Ontario Power Generation Inc.

**Revised Submission to the CNSC Public Hearing on Ontario Power Generation
Application to Renew the Reactor Operating Licence for Darlington Nuclear Reactors**

Hearing Number Ref. 2015-H-04

Review of Severe Accident Progression Without Operator Action, CNSC Report published October 2015

Figure 1 : Boiler boiloff time of 5 hours reproduced for illustration.

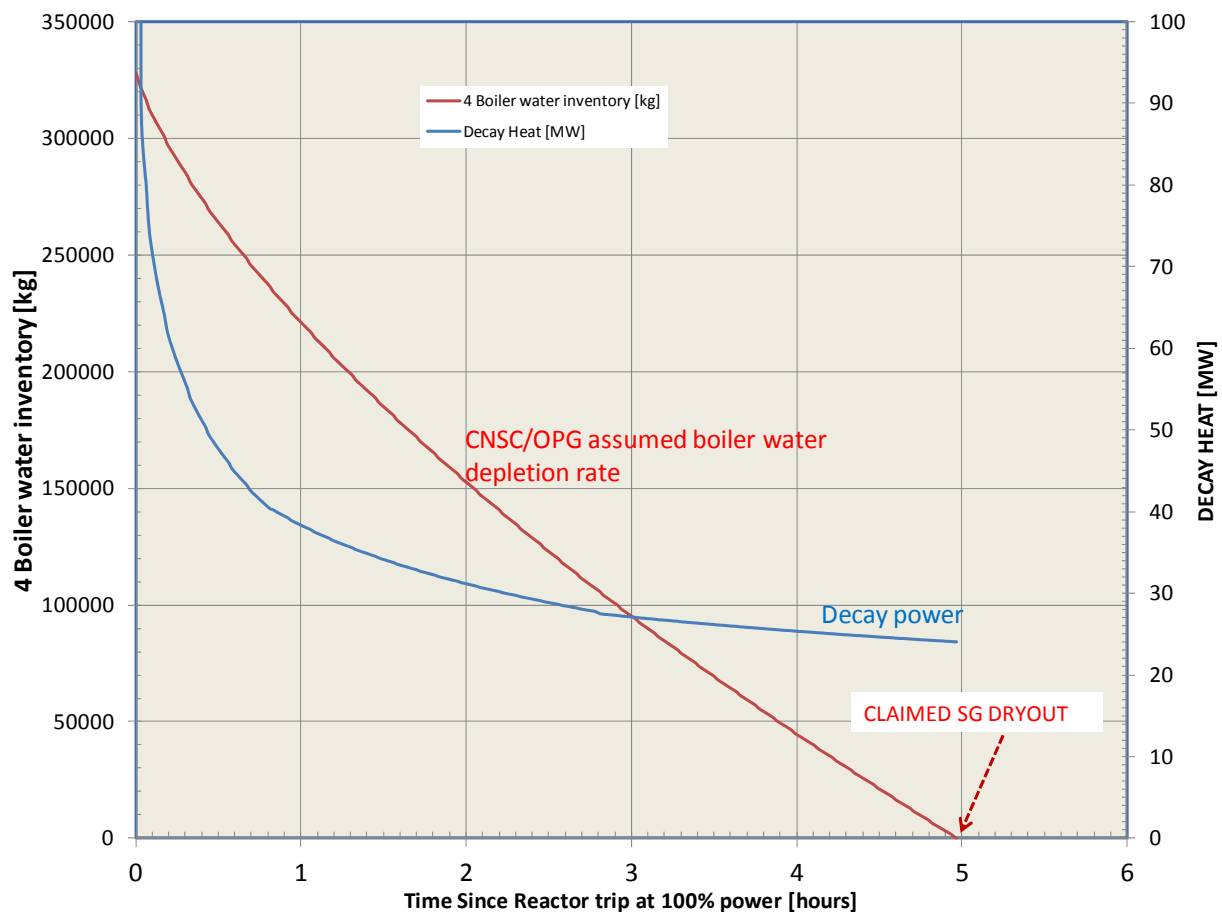
I have reproduced below the 5 hour prediction by assuming an initial inventory secondary side inventory of 328 tons (82 Mg per boiler) and assigning all decay heat from an initial 2650 MWth fission power and considering 3MW constant heat loss from the HTS. This requires that a number of additional heat sources be not credited and that what seems to have been done to arrive at the 5 hour prediction.

While it is debatable whether the 42 Mg of inventory is the correct input for the best estimate calculations, even the upper limit of 82 Mg gives us little help in justifying the wild 5 hour claim.

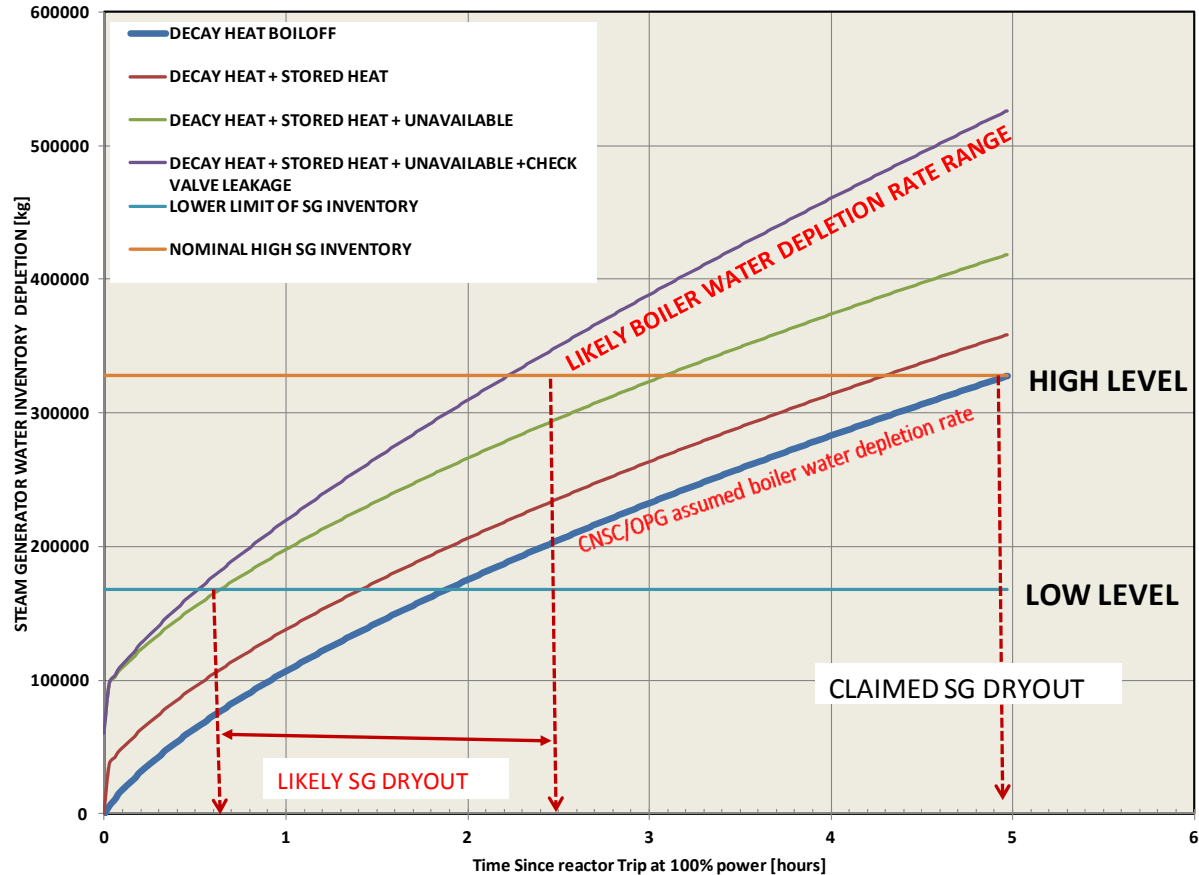
Figure 3 shows realistic estimates of boiler dryout time. It is shown that the boilers may cease to be effective heat sinks that promote primary system heat removal by thermo siphoning at about 2 hours.

Figure 9: US PWR estimates of a Station Blackout Scenario presented as an illustration of potential range of event frequencies.

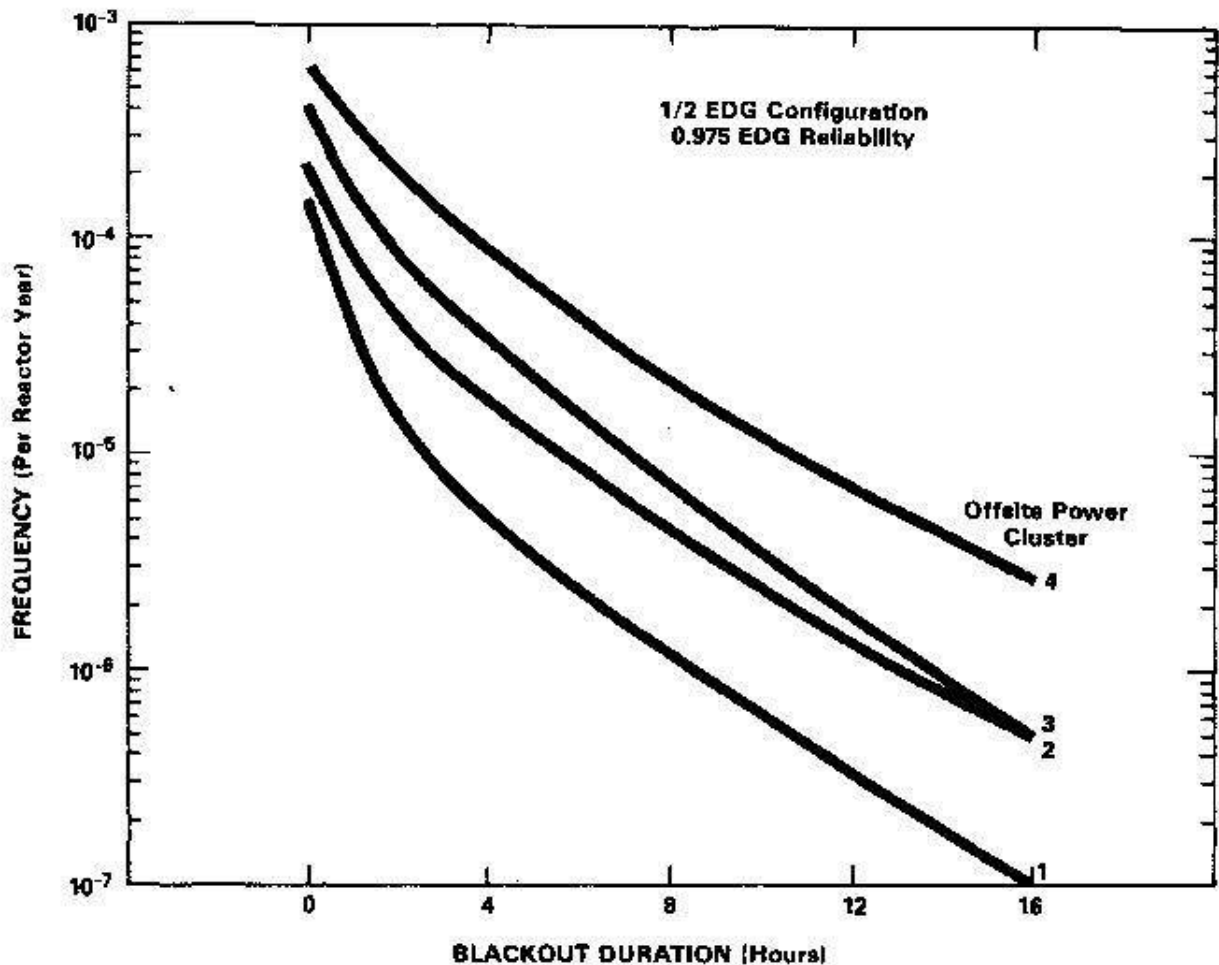
The claim of station blackout being a $1E-7$ event is borne neither by Canadian PSA nor US data and is not consistent with the established PRAs and in conflict with Darlington PSA results. Results for US PWRs as summarized in figures below indicate a much higher frequency.

Figure 20: Darlington HTS over pressure protection - Left arrow shows SRVs, right arrow shows LRVs

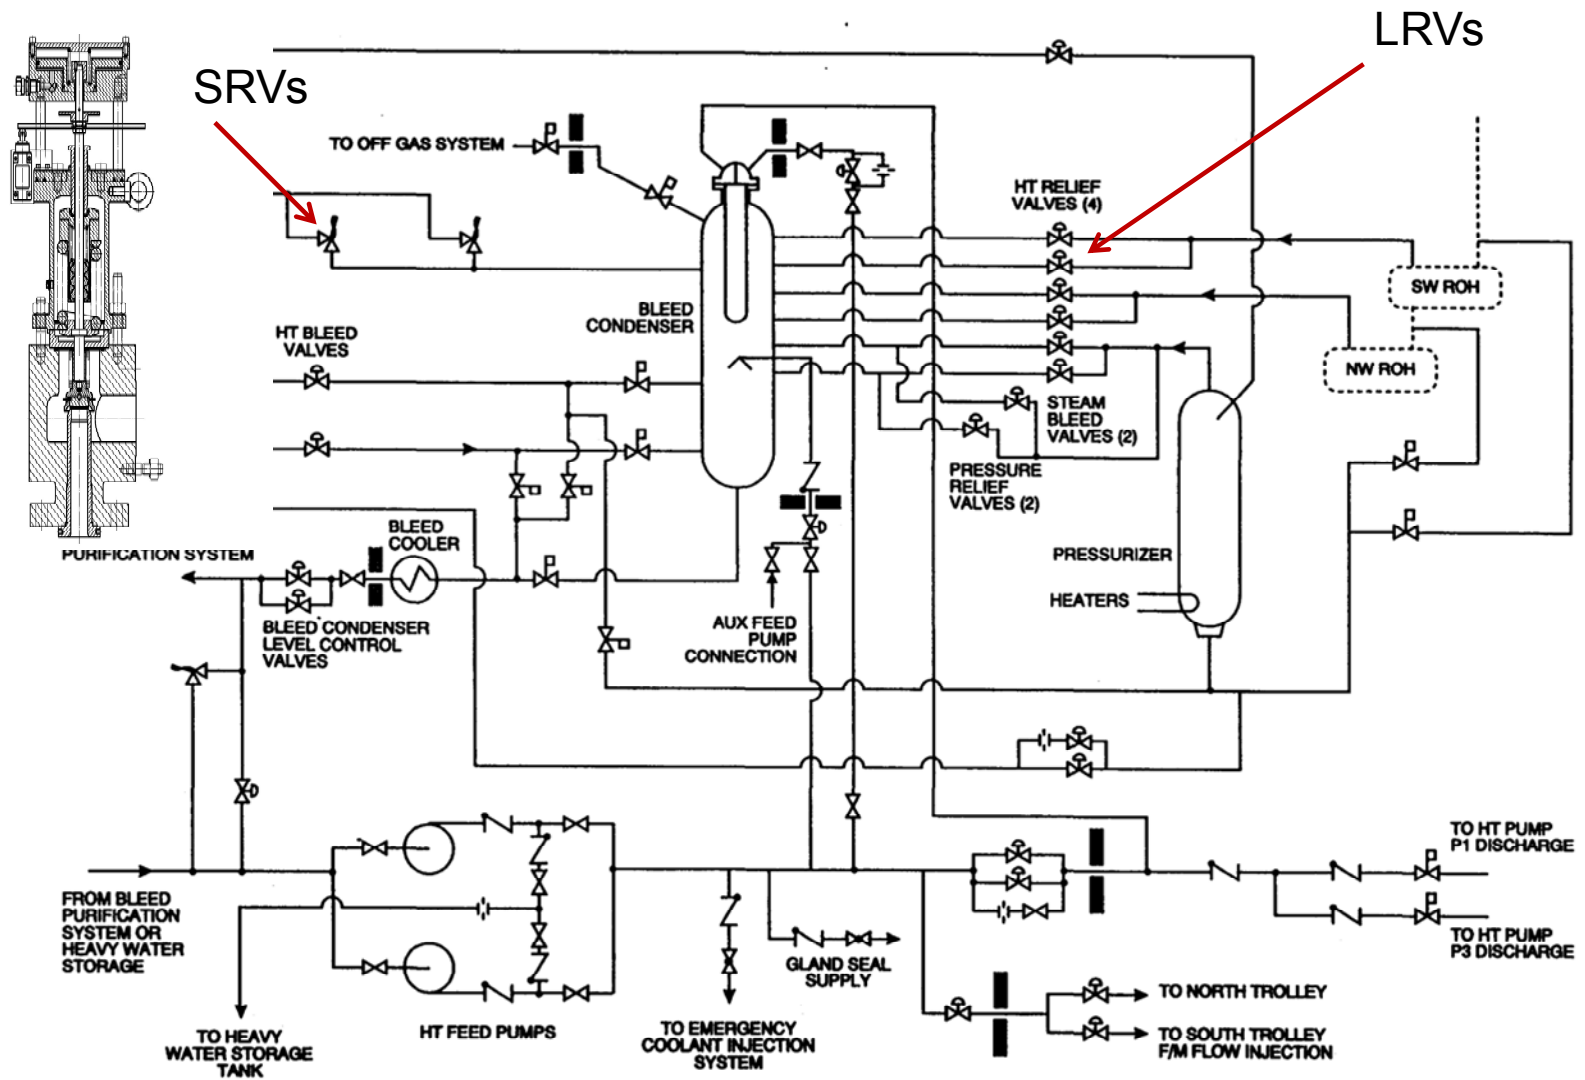
Darlington NGS over pressure protection on the main heat transport system (HTS) is atypical of pressurized water reactors. (the fact that the design is atypical is not the issue but that the over-pressure mitigation capability of the implemented design is inadequate upon a loss of heat sinks). Instead of being a direct and unobstructed relief path as required by the ASME code, section III, NB-7141 (b) - it is composed of two sets of valves in series (Figure 20), separated by a small low pressure vessel called the bleed condenser. The first set of valves are typically called Liquid Relief Valves (LRVs) and the second set of valves are called Safety Relief Valves (SRVs), although both sets are designed in CANDUs for a certain liquid relief with a small steam relief capacity, typically also not certified. Under conditions of boiler heat sink termination, these valves must pass enough steam to match that produced by decay heat, in order to avoid an over pressure.

The design value of the steam relief is inadequate just by inspection. It was easily shown by application of a simple ASME equation on the actual valve geometries (tested flow area of about 35 mm² in steam) that the SRVs can never discharge enough steam (Figure 23) to avoid an overpressure. It was also shown by some AECL testing at Wylie Labs & valve spring analysis that the valves cannot open fully under steam conditions (lift of about 1mm out of a total possible lift of 4mm) and thus are only able to relieve less steam than needed. A proper over pressure protection will not be available when required. This can result in an uncontrolled rupture of the pressure boundary.

Figure 24 : AECL calculations confirming that the steam relief capacity of the Bruce type safety relief valves at <10 kg/s is inadequate and will cause uncontrolled ruptures

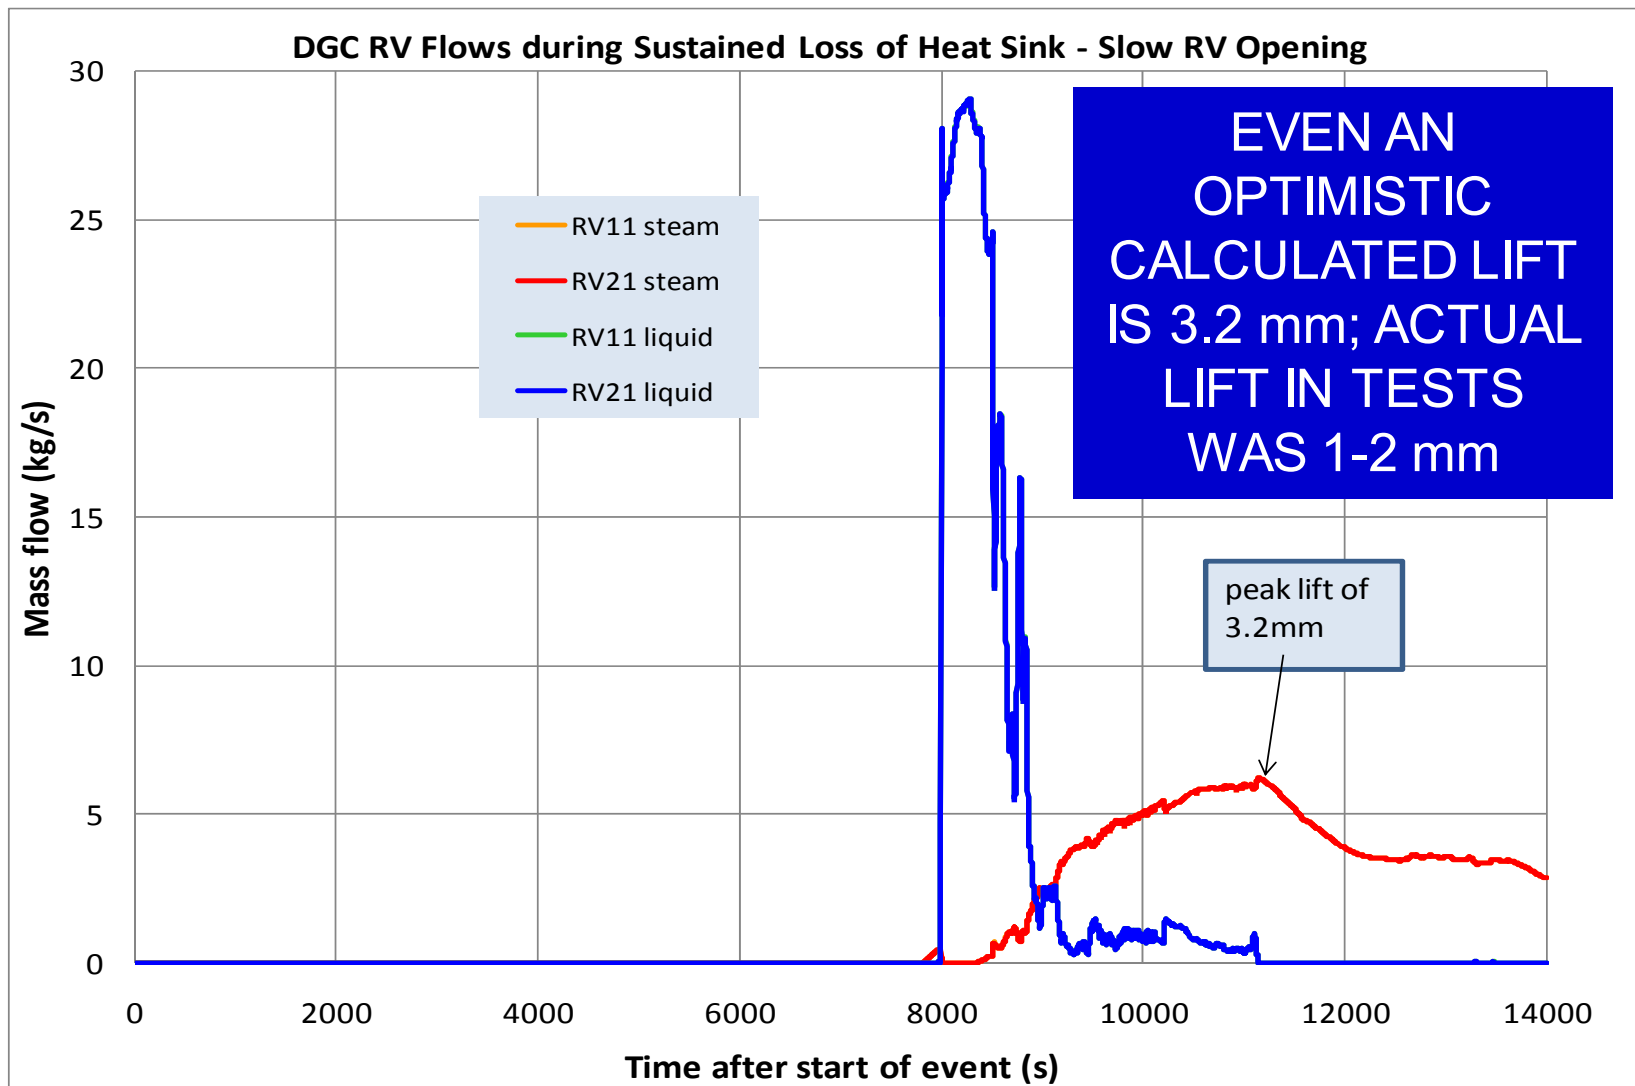
It is clear that the subject valves, replacing a properly designed valves in 1996, are ill designed for ALL CANDU reactors and their designer specified steam relief capacity of ~1.5 to 2 kg/s of steam is just not sufficient to remove energy production at the time when they are required to work. The subject Darlington SRVs were actually designed for **liquid** relief of about 100 kg/s and a steam relief of less than 2 kg/s as per their submissions to the CNSC. Tests showed that these valves lift fully under liquid relief conditions but lift only partially (20%) under steam relief conditions (thrust force by steam on valve seat is significantly lower than for liquid water). The discharge area is proportional to lift and is significantly smaller for steam. This was confirmed by testing and actually an engineered valve spring feature to meet the design specifications of 1.5 to 2 kg/s of steam discharge capacity. The reactors must enhance the over protection system by installing safety relief valves that preclude a pressure boundary failure. AECL confirmed the inadequacy of the steam relief capacity (Figure 24) in analyses presented in 2011.
